SUBJECT: SEABROOK STATION, UNIT NO. 1 - ISSUANCE OF AMENDMENT
REGARDING LICENSE AMENDMENT REQUEST REGARDING FUEL
STORAGE CHANGES (TAC NO. ME8688)

The Commission has issued the enclosed Amendment No. 142 to Facility Operating License No. NPF-86 for the Seabrook Station, Unit No. 1. This amendment consists of changes to the facility technical specifications (TSs) in response to your application dated January 30, 2012, as supplemented by letters dated May 10, 2012, September 20, 2012; March 27, 2013, December 20, 2013; and January 29, 2014.

AMENDMENT TO FACILITY OPERATING LICENSE

SAFETY EVALUATION BY THE OFFICE OF NUCLEAR REACTOR REGULATION

FIGURE 5.6-1

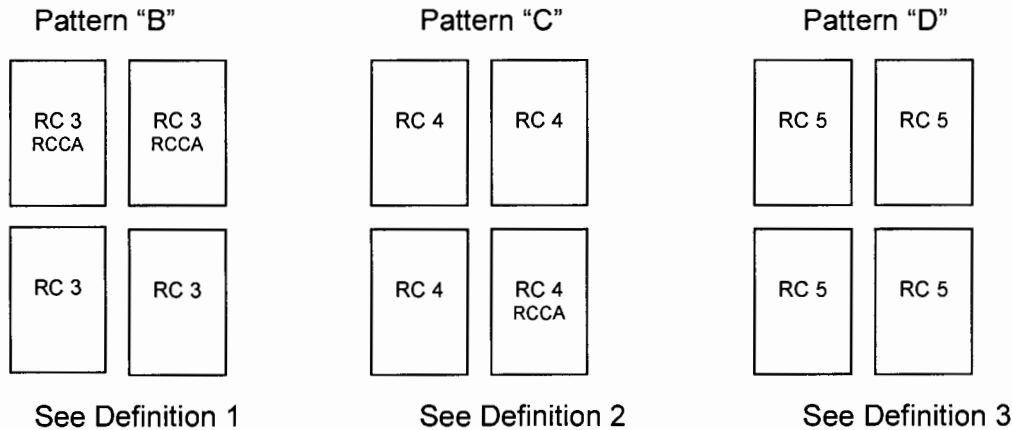
1. Allowable pattern is fuel assemblies that meet Reactivity Class (RC) 1, 2, 3, 4, or 5 checkerboarded with fuel assemblies that meet RC 2, 3, 4, or 5. Requirements for all RC are defined in Table 5.6-1. Diagram is for illustration only.

1. There are no interface limitations within Region 1 between rack modules or within racks. Each cell is a part of up to four 2x2 arrays, and each cell must simultaneously meet the requirements of all those arrays of which it is a part.
2. Replacement of any fuel assembly by an empty water hole, non-fuel hardware or fuel rod storage basket is acceptable.

New TS 5.6.1.3, Tables 5.6-1 and 5.6-2, and Figures 5.6-1 and 5.6-2 provide the detailed requirements for storage of fuel in the Seabrook SFP.
